**SAN FRANCISCO BAY TRAIL BOARD OF DIRECTORS
SPRING 2016 MEETING**

2:00 p.m.	Bay Trail Design Guidelines & Toolkit Approval* <i>Staff and consultants will provide an overview of the Bay Trail Design Guidelines & Toolkit.</i>	2M Associates, Placeworks

Over the last year, Bay Trail staff has been working with a consultant team led by 2M Associates, to develop a more robust Bay Trail Design Guidelines and Toolkit in order to assist Bay Trail staff in their everyday work as they engage a wide variety of stakeholders. The purpose of the Design Guidelines and Toolkit is to 1) impart the vision and principles of design for the Bay Trail and 2) provide design guidance and a design resource that will aid the development of the Bay Trail in a manner that results in a regional trail system that provides an enjoyable, safe, continuous, and useable experience for the broadest range of non-motorized users possible.

Horizontal Obstructions

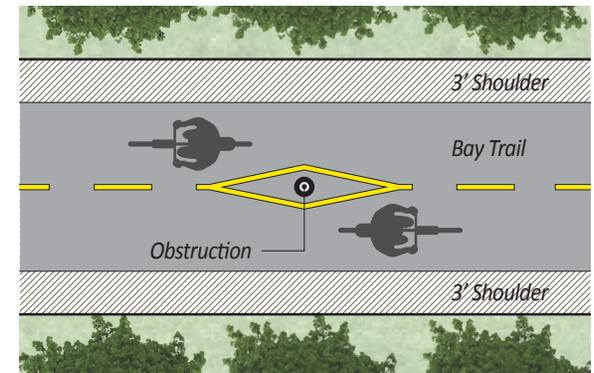
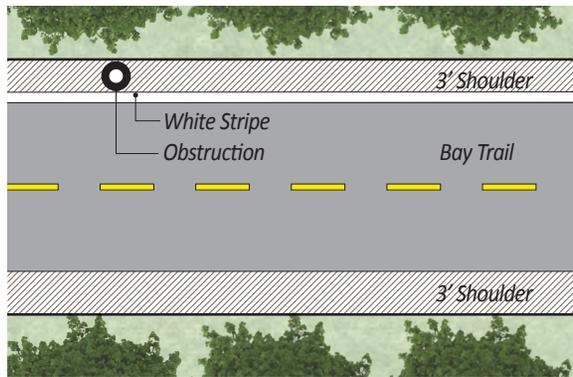
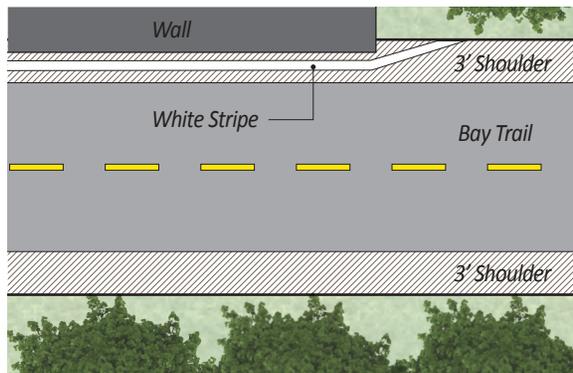
Page 33: The Obstructions section seems to state that it is OK to have a curb, wall, railing, etc. within 3' of the paved surface, i.e. adjacent to edge of trail shoulder. Rather, such obstructions should be 3' recommended and 2' minimum from outer edge of shoulder. People can't jog or walk against a wall, railing, etc.	Text changed to read " When an obstruction is unavoidable within the trail shoulder, a solid white stripe should be located along the edge of the trail to visually notify the Bay Trail user about the presence of the obstruction." <u>Response:</u> The suggestion is not to put an obstruction in the trail or shoulder; just the opposite. However, there are often obstructions that while not desirable or wanted, need to be addressed. And in other conditions, such as in a tunnel, there is no "shoulder".
Page 34: Based on TRAC'S experience, bollards should be installed when the trail is built. When bollards weren't installed initially, retrofit always has been necessary due to motor vehicle incursions.	<u>Response:</u> The direction is to discourage bollards. The timing of including bollards is up to the managing agency.

FIGURE 5-4: CLEARANCE BETWEEN THE BAY TRAIL AND STREETS

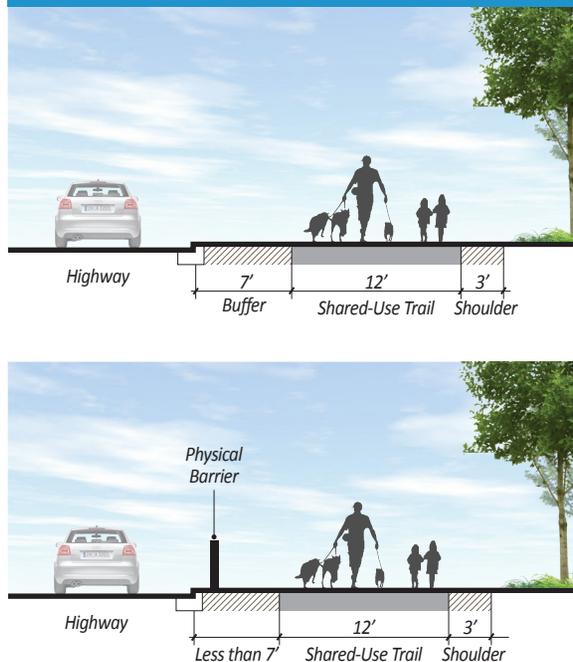
Page 35: The separation distance specified should be from outer edge of trail shoulder, rather than the paved surface. Caltrans' minimum is 5' without a physical barrier.	<u>Response:</u> The Highway Design Manual Chapter 1000 has a mandatory design standard that states: "The minimum separation between the edge of pavement of a one-way or a two-way bicycle path and the edge of traveled way of a parallel road or street shall be 5 feet plus the standard shoulder widths." The standard shoulder width is 2 feet. 5+2 = 7.
Page 36: Center lines don't add enough value to justify the cost of installation and maintenance. None of Richmond's 32 miles of Bay Trail has a center line with	<u>Response:</u> Agree that centerlines are not necessarily desirable and most agencies try to avoid them. However, there are many

Restrooms

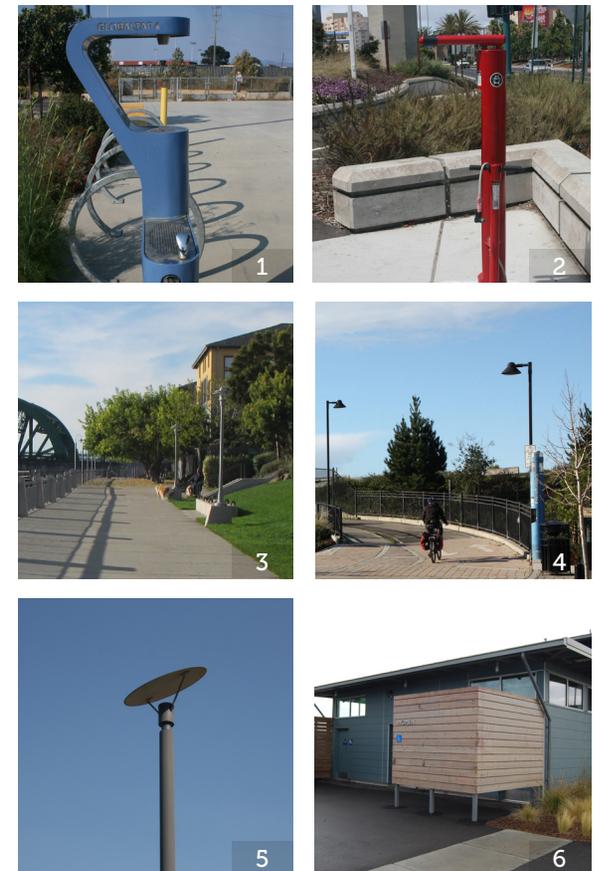
Page 55, Restrooms: 1-mile intervals? Unrealistic most places.	<u>Response:</u> Change to 2-mile intervals to be consistent with drinking fountains.
Page 56: EBRPD is moving toward security cameras at a staging areas..	<u>Response:</u> Text already includes security cameras.
Page 56, Middle graphic: There are not many types of trees that will grow along the Bay.	<u>Response:</u> The BCDC guidelines for shoreline plants include trees.
Page 56, photo credit: “Portland” typo.	Name removed.
